RW-174

AMENDMENTS TO THE DRAWINGS:

REMARKS

FIG.1

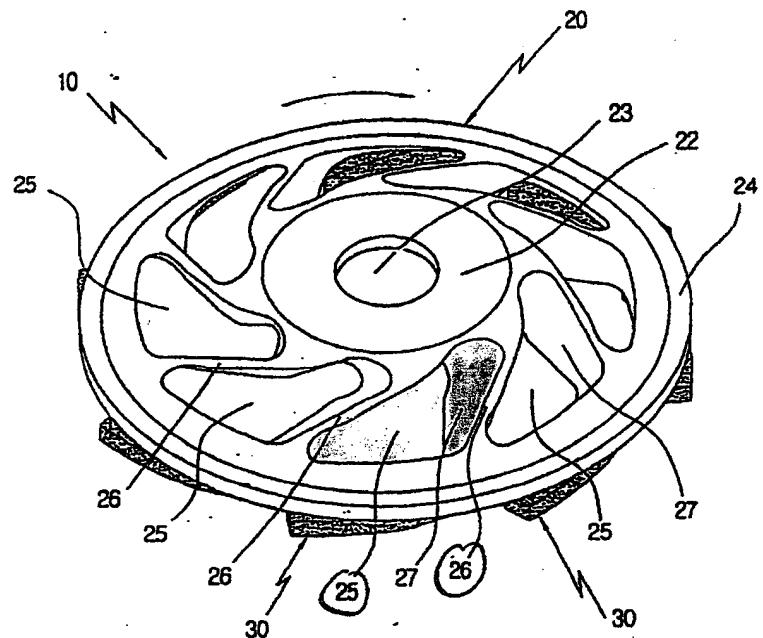
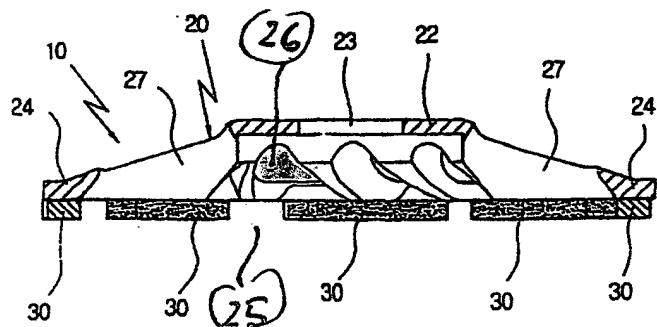
Turning now to the reference, it can be seen that the patent to Lee discloses a grinding wheel for use in a grinding apparatus. The grinding wheel has discharge holes 25 that work together with a dust removal device for removing dust. The holes 25 do not have specially formed edge regions and thus there are no aerodynamically favorable formed dust suction openings for optimizing the airflow with the grinding dust.

That the grinding plate of Lee does not have aerodynamic dust openings can be seen in Figs. 1 and 2 of Lee. "25" indicates the

openings and "26" indicates the discharge-impelling blades.
